ATTACHMENT A - DESCRIPTION OF PROPOSED CHANGES

ATTACHMENT B - TECHNICAL SPECIFICATION CHANGES

Figure
2.1-1a

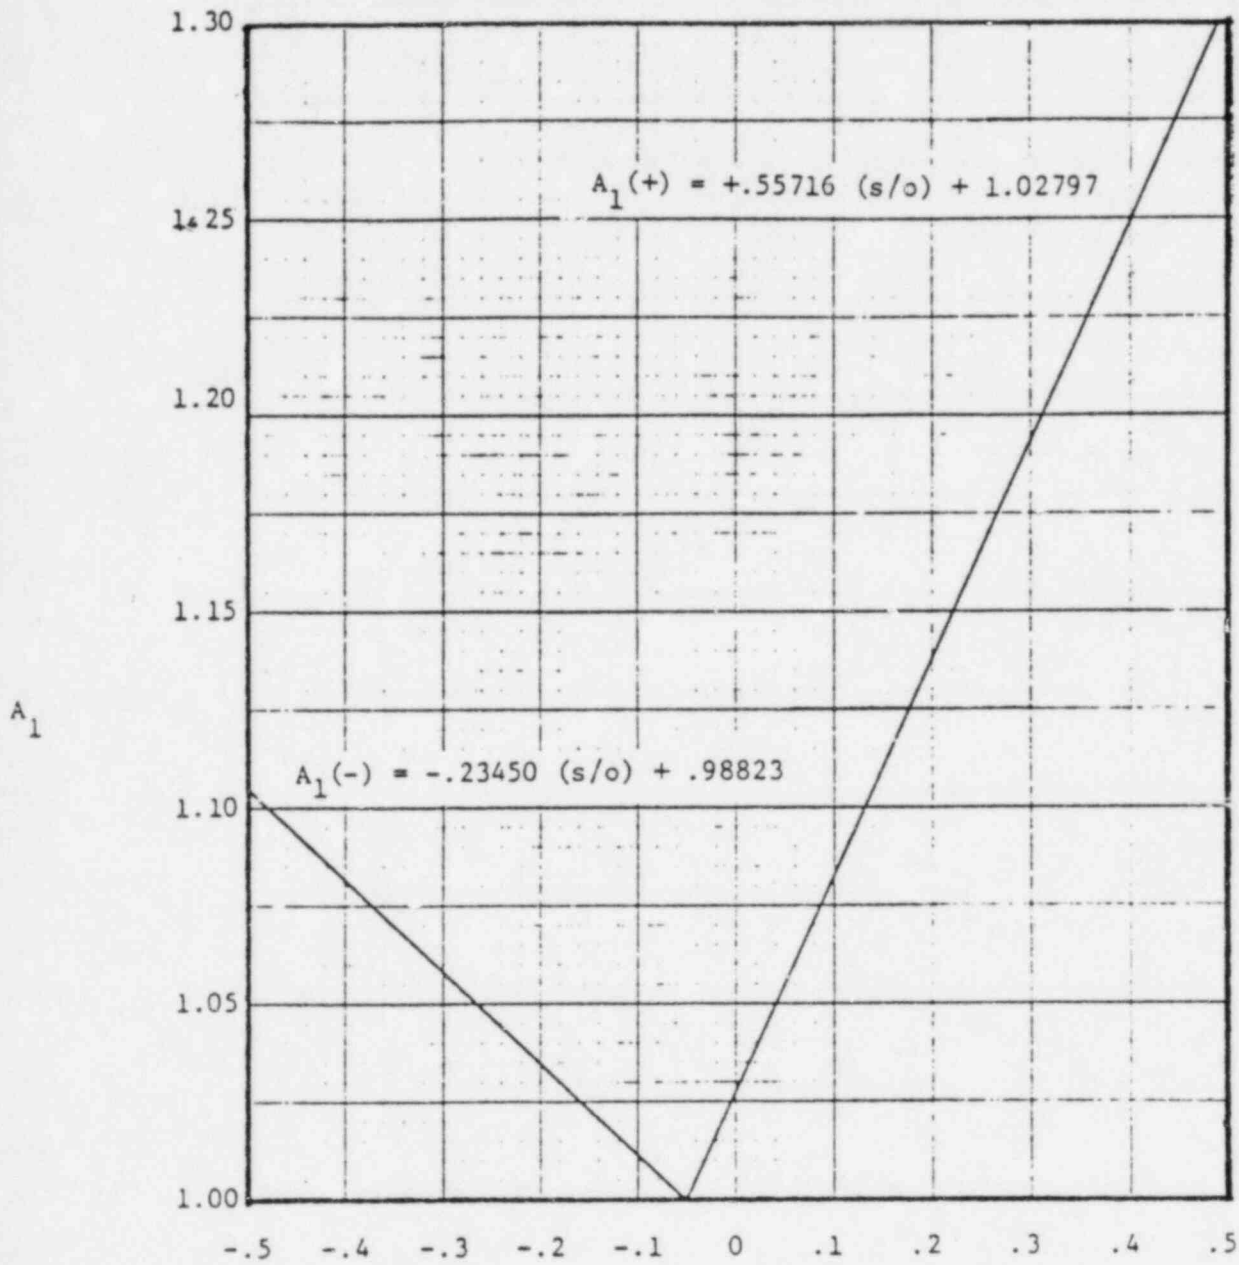
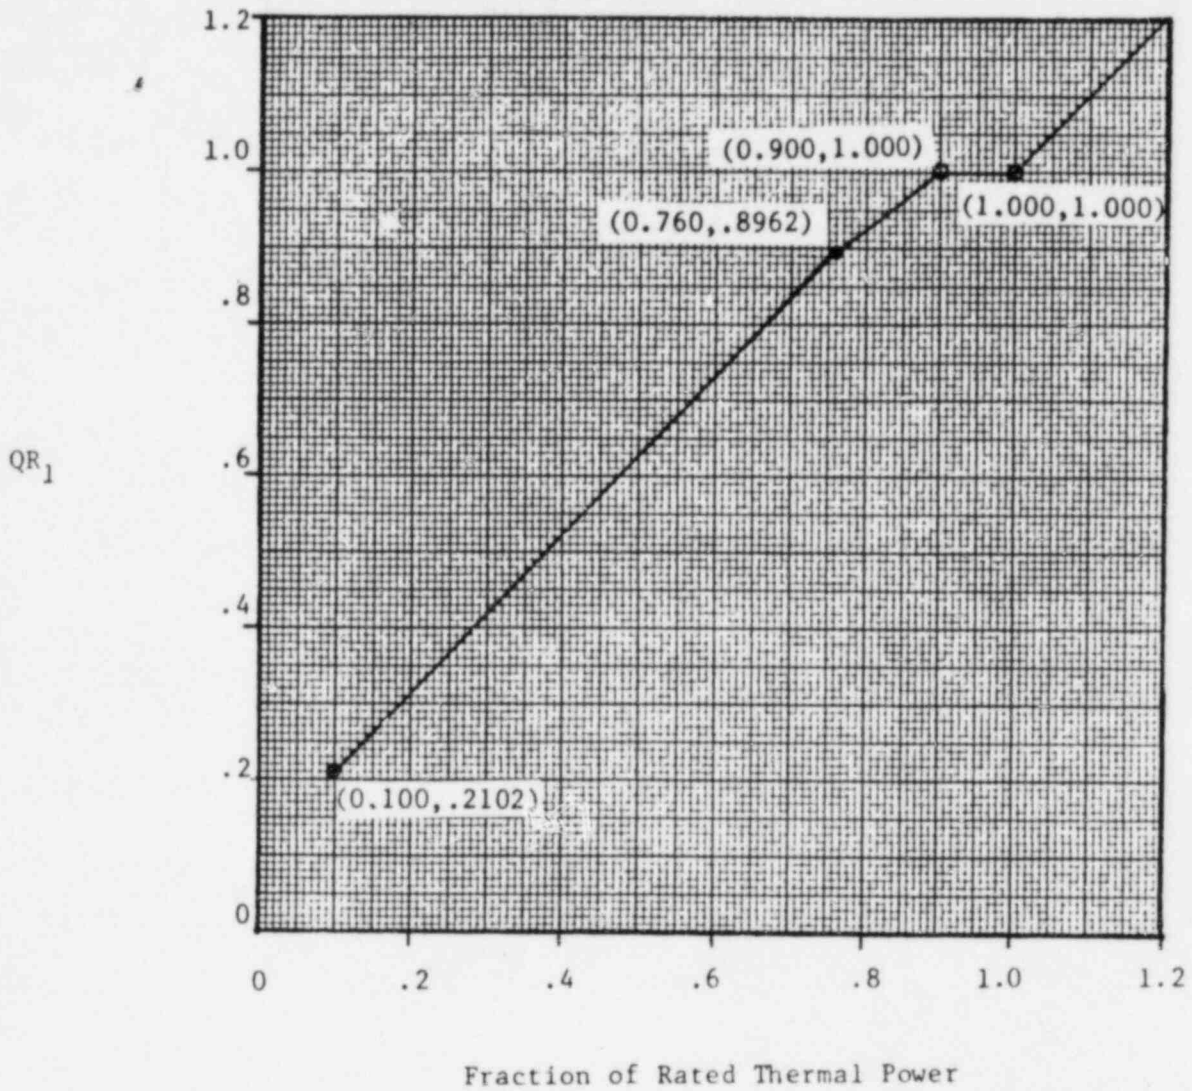
3.	2.1 pages 2.1-1 through 2.1-5	<p>a) Thermal margin/low pressure trip coefficients modified.</p> <p>b) DNB SAFDL reference modified.</p> <p>c) Figures 2.1-1a and 2.1-1b modified.</p>	<p>a) Reflects Cycle 7 power distributions.</p> <p>b) Reflects use of YAEC-1 DNB SAFDL to generate LSSS (Section 6.0 of YAEC-1324).</p> <p>c) Reflects Cycle 7 power distributions and YAEC-1 DNB SAFDL (Section 6.0 of YAEC-1324).</p>

Figure
3.10-1

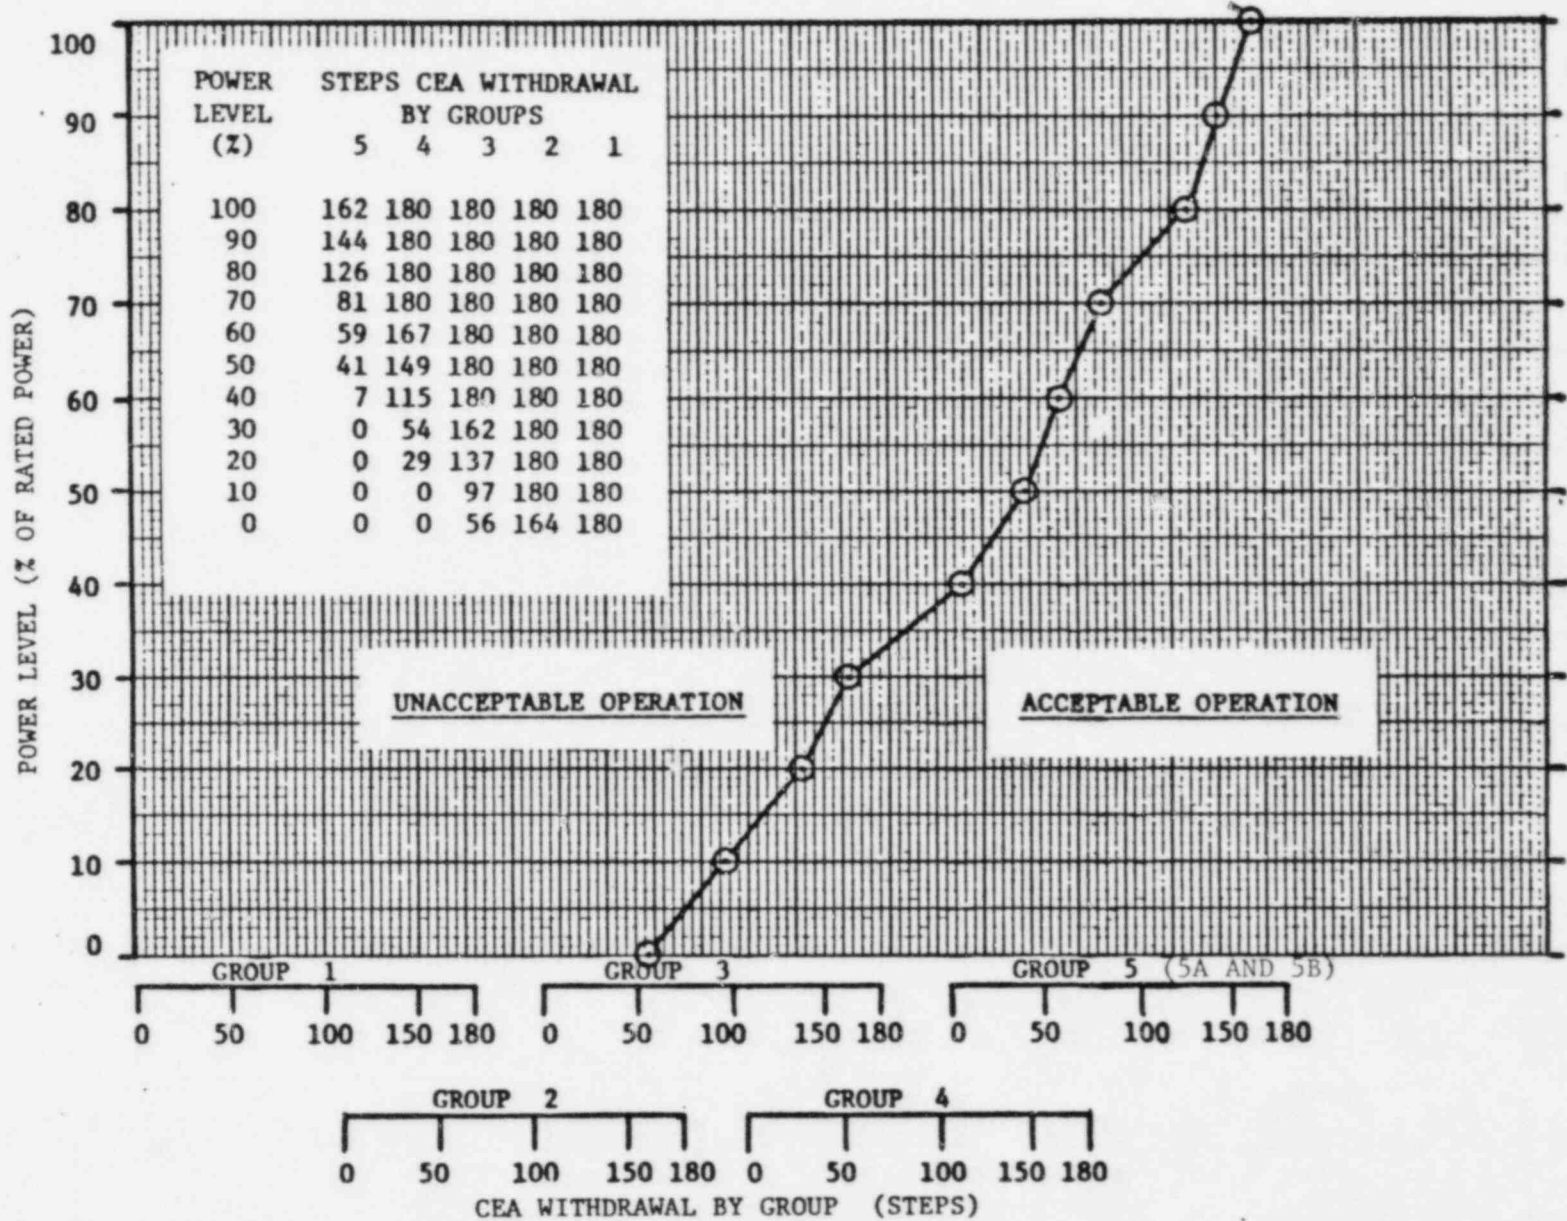
u)	Bases	discussion on natural circulation exception added.	u) Clarification of exception.
v)	Figure 3.10-1	modified.	v) Reflects Cycle 7 CEA insertion limits (Section 4.9.1 of YAEC-1324).

<p>MAINE YANKEE TECHNICAL SPECIFICATIONS</p>	<p>EXCORE MONITOR SYMMETRIC OFFSET ALARM BAND FOR LOCA LIMITING CONDITIONS OF OPERATION WHEN INCORE MONITORS ARE INOPERABLE AND CEAs RESTRICTED ABOVE THE 100% RATED POWER INSERTION LIMIT. 3 .10 - 10</p>	<p>FIGURE 3.10-2 SEP 29 1982</p>
--	--	--

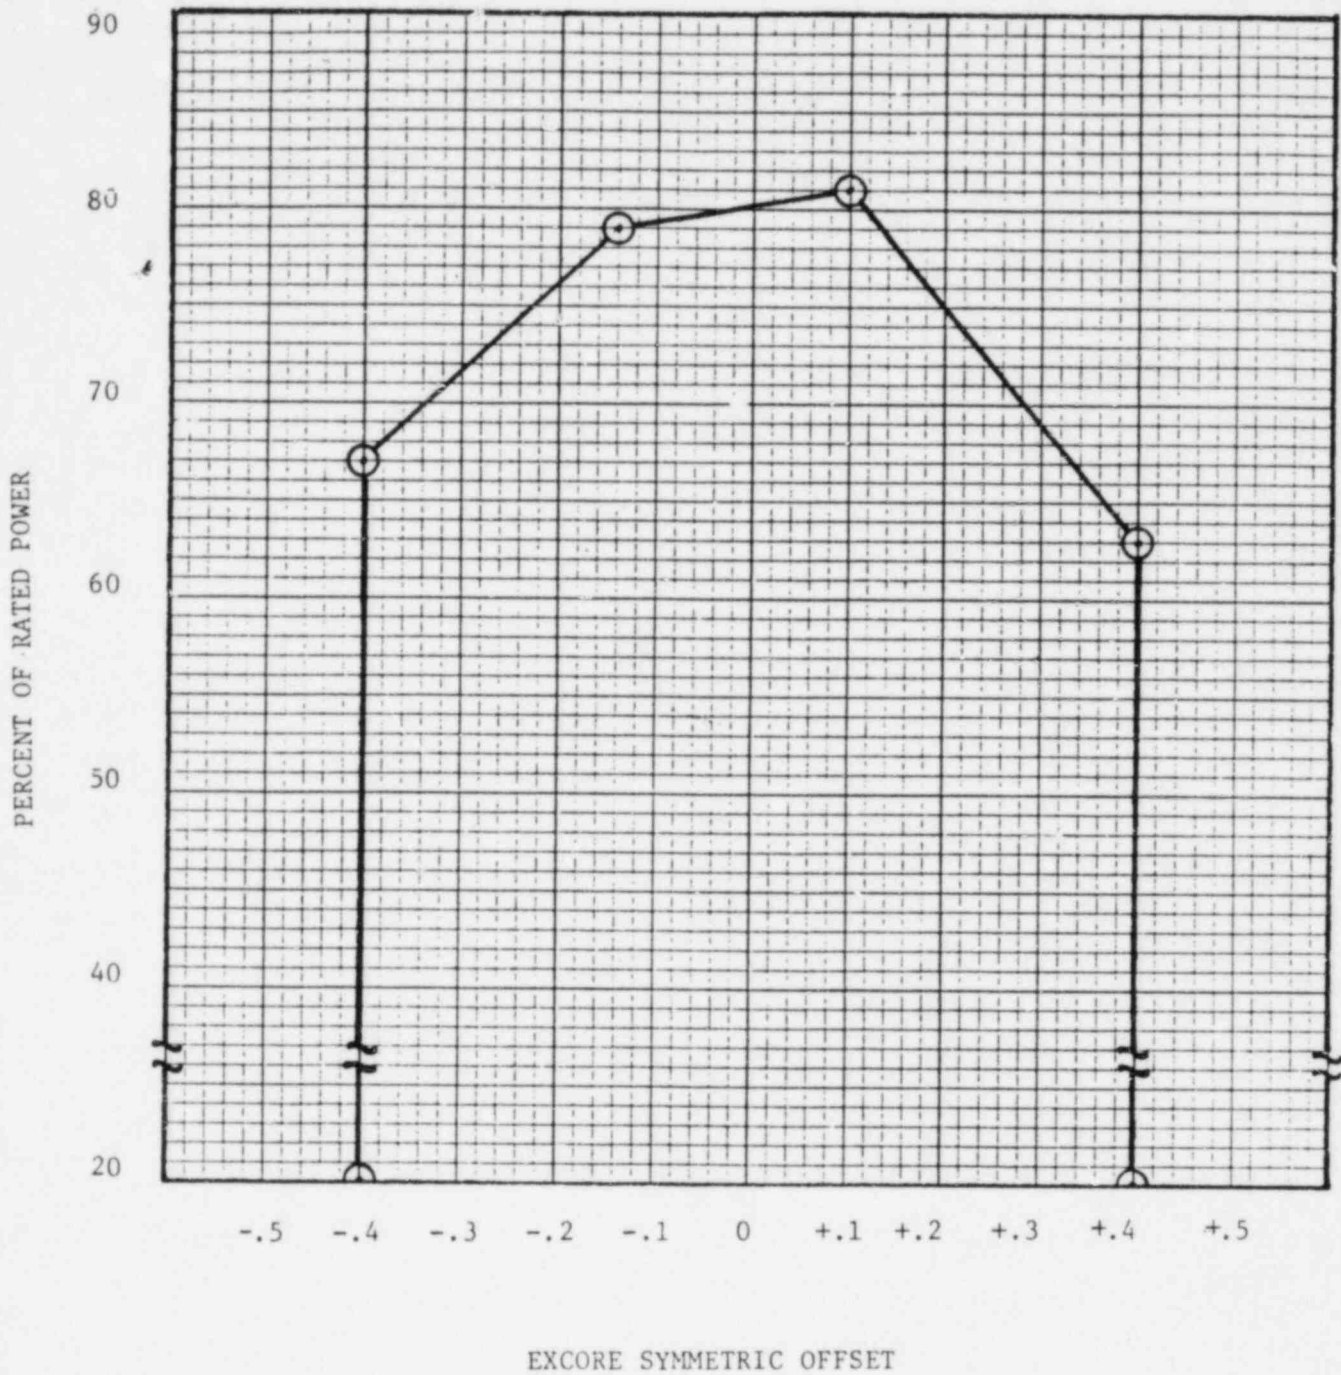
w)	Figures 3.10-2 and 3.10-3	modified.	w) Reflects Cycle 7 power distributions.
x)	Figure 3.10-4	modified.	x) Reflects Cycle 7 radial peaking (Section 4.3 of YAEC-1324).

Figure
3.10-5

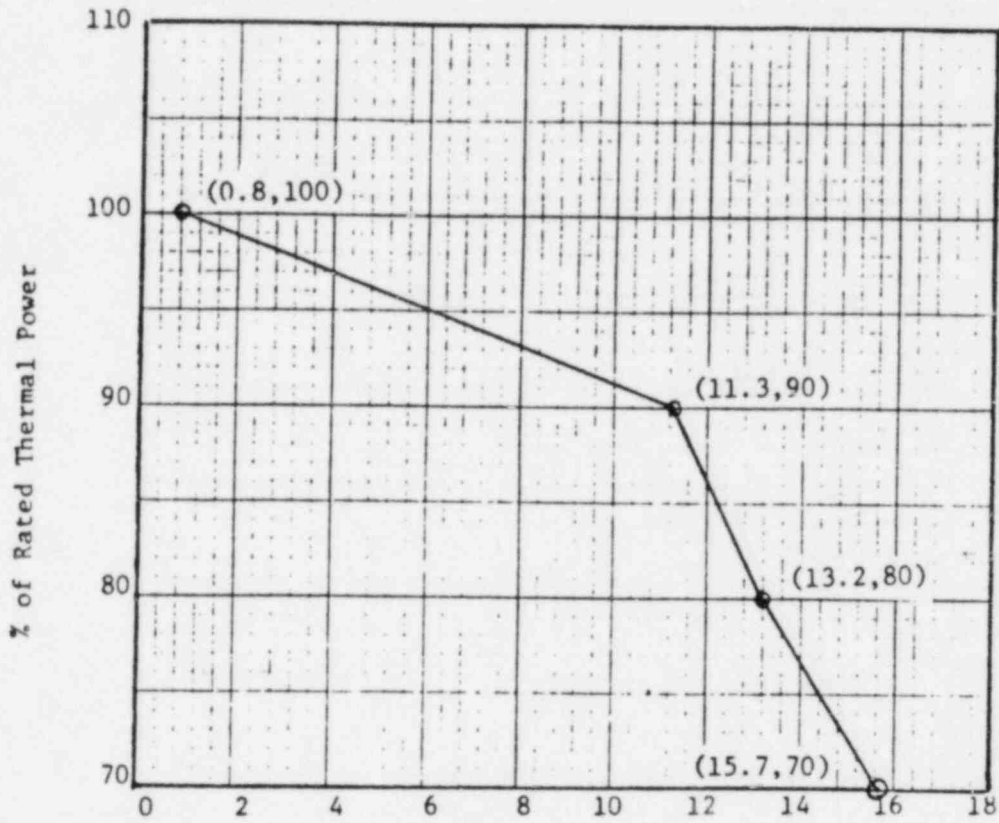
y)	Figure 3.10-5	modified.	y) Reflects Cycle 7 power distributions and RPS setpoints.
z)	Figure 3.10-7	modified.	z) Reflects Cycle 7 required shutdown margin (Section 4.9.5 of YAEC-1324). Provides power level and RCS boron concentration dependence consistent with shutdown margin in definition section.
